UNITED STATES PATENT AND TRADEMARK OFFICE

APPLICATION NO.	FILING DATE	FIRST NAMED INVENTOR	ATTORNEY DOCKET NO.	CONFIRMATION NO.
10/009,990	06/30/2003	Earl Harling	NIDN-73132	6720

Office Action Summary	Application No. 10/009,990	Applicant(s) HARLING ET AL.	
	Examiner Amadeus S. Lopez	Art Unit 3743

DETAILED ACTION

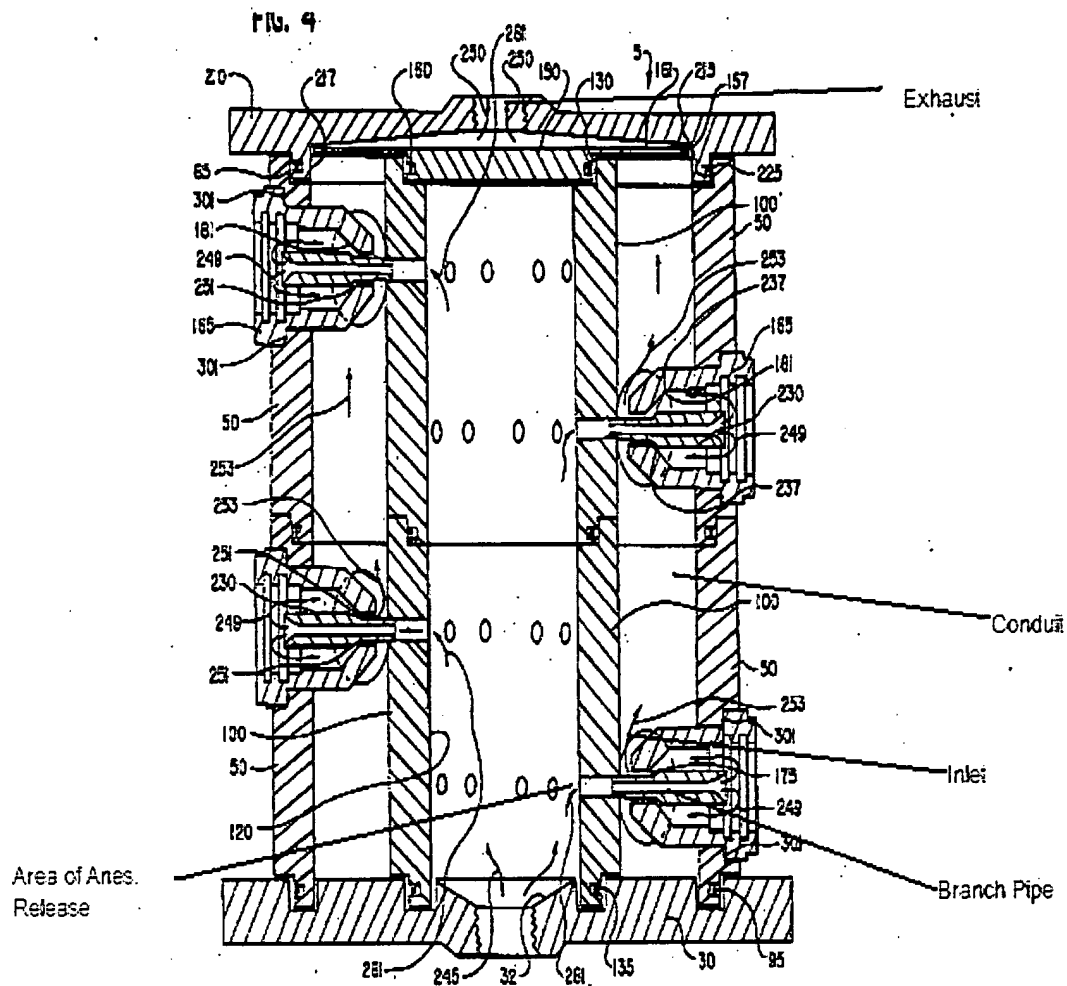
1. **With regards to claims 1, 16, and 17** what is taught and shown by Jaeger in figs. 1 and 4 is a ventilation system for reducing the amount of anaesthetic released from an anaesthetic administration station into a small animal surgery suite, the system comprising at least one inlet (labeled in figure 4 below) positioned adjacent to at least one area of anaesthetic release (See figure 4 below) from the anaesthetic administration station (10), and a conduit leading from the inlet to an exhaust (both conduit and exhaust labeled in figure 4 below), said anesthetic administration station is an induction chamber (10; Fig. 1), where animals are initially anesthetized and wherein the inlet is provided on the side of the induction chamber. What is not disclosed by Jaeger is that the inlet is located above the induction chamber. It would have been obvious to one having ordinary skill in the art at the time the invention was made to provide the inlet above the induction chamber, since it has been held that rearranging parts of an invention involves only routine skill in the art. *In re Japikse*, 86 USPQ 70. Since Jaeger teaches all the elements and the claimed configuration of the ventilation system, the method of installing this system for reducing the amount of anaesthetic released from an anaesthetic administration station would have been obvious through the set up and use of the ventilation system of Jaeger.

2. **With regards to claim 2**, what is taught and shown is a ventilation system wherein the system comprises a plurality of areas of anesthetic release an inlet adjacent to each area (See figures 1 and 4 above; wherein it is shown that each induction chamber has an inlet and area of anesthetic release associated with it).
3. **With regards to claim 3**, what is taught and shown by Jaeger in figures 1 and 4 is a ventilation system wherein said conduit comprises a main pipe (located as conduit in fig 4 above) connected at one end to the exhaust (gases are removed from the induction chamber via the conduit that leads to the exhaust outlet 214; Col. 11, line 67 to Col. 12, line 10).

11. **With regards to claim 15**, what is taught and shown by Jaeger et al in figs 1 and 4 is a ventilation system wherein the inlet is formed as an annulus surrounding the orifice (See figure 4 above wherein the inlet is shown to surround the area where the anesthetic is delivered to the animal).
